SERVICE LETTER

No-643

Control Shaft Collar Restraining Strap

PA-31 and PA-31-300 Navajo
PA-31P Navajo

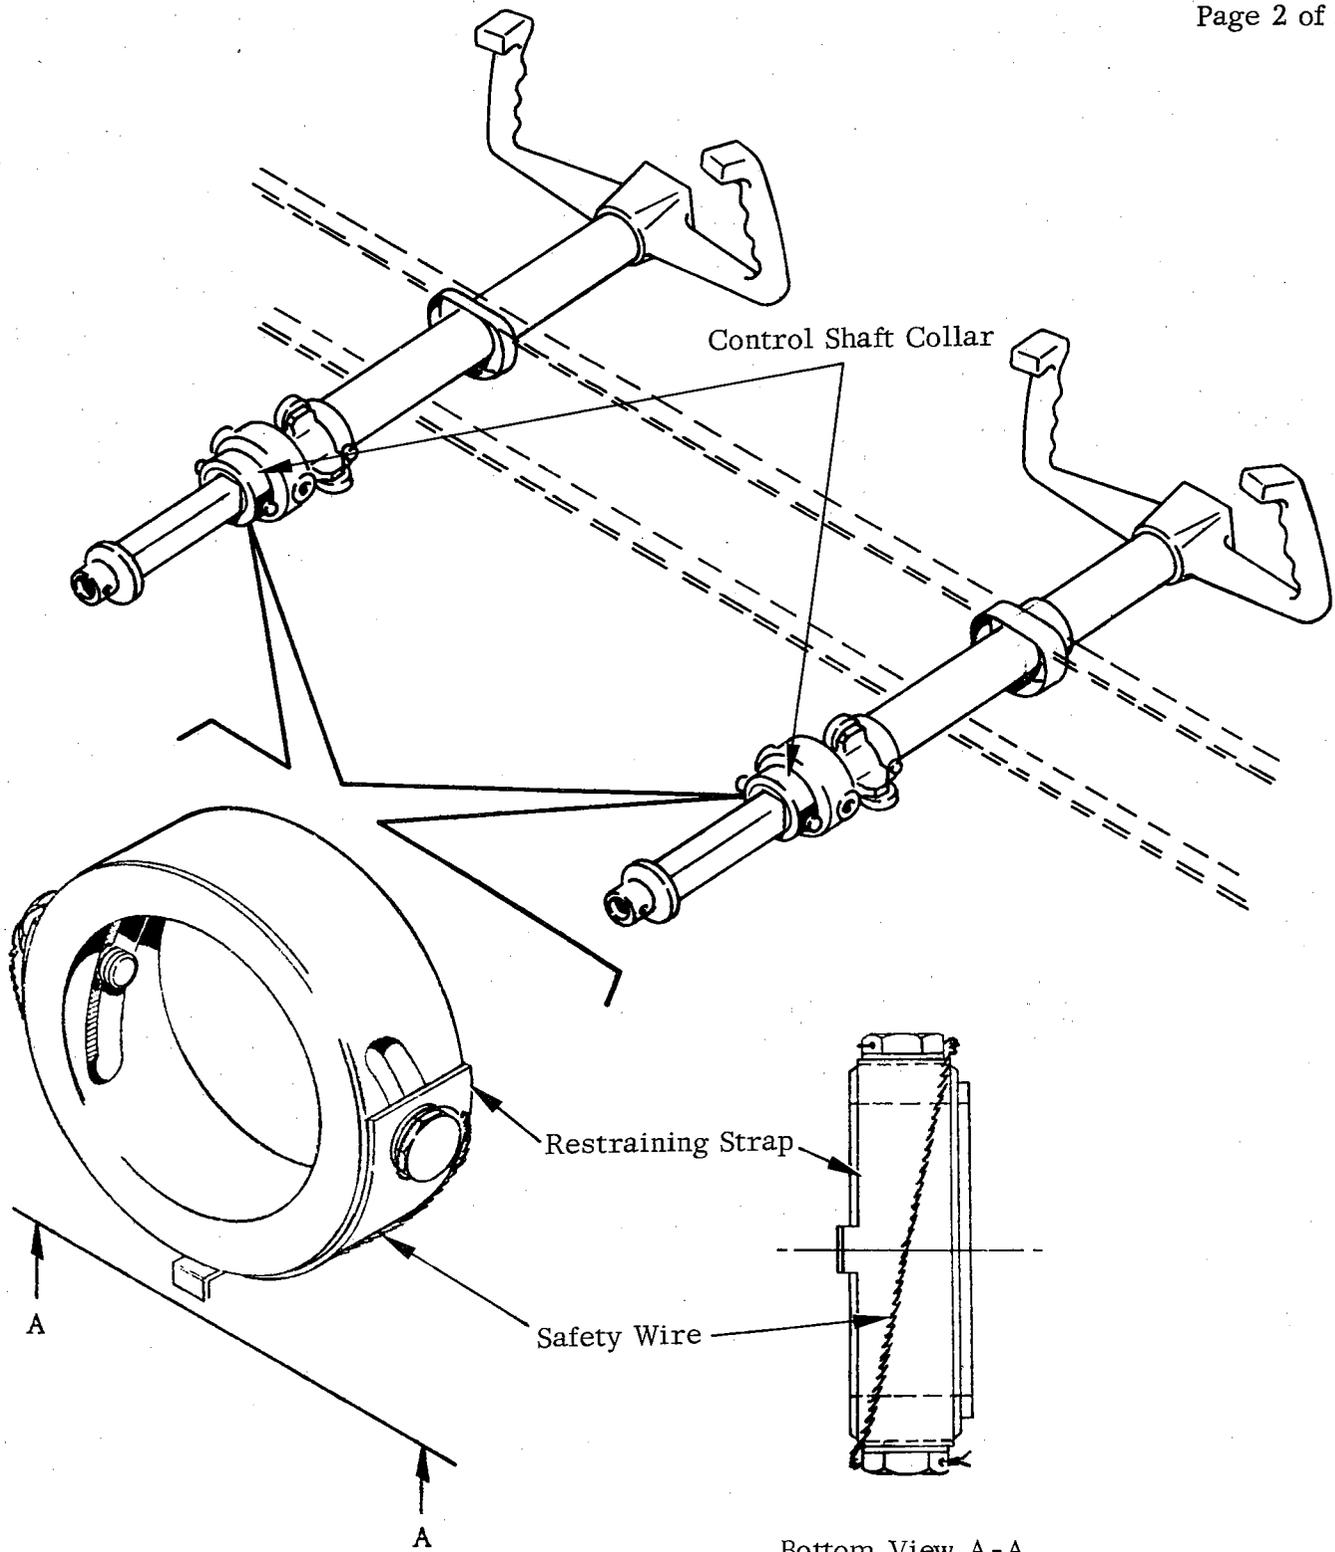
A recent field report has indicated the need for the addition of a safety wire restraining strap and a revised safety wiring method regarding the attachment of the control shaft collar to the control shaft tube assembly.

This service release provides material and instructions for the installation of a safety wire restraining strap and to revise the control shaft collar safety wiring (refer to sketch on reverse side of this Service Letter for a general illustration).

Contained in Piper Part No. 760 723, Control Shaft Collar Restraining Strap Installation Kit.

One (1) each (per aircraft) Piper Part No. 760 723, Control Shaft Collar Restraining Strap Installation Kit.
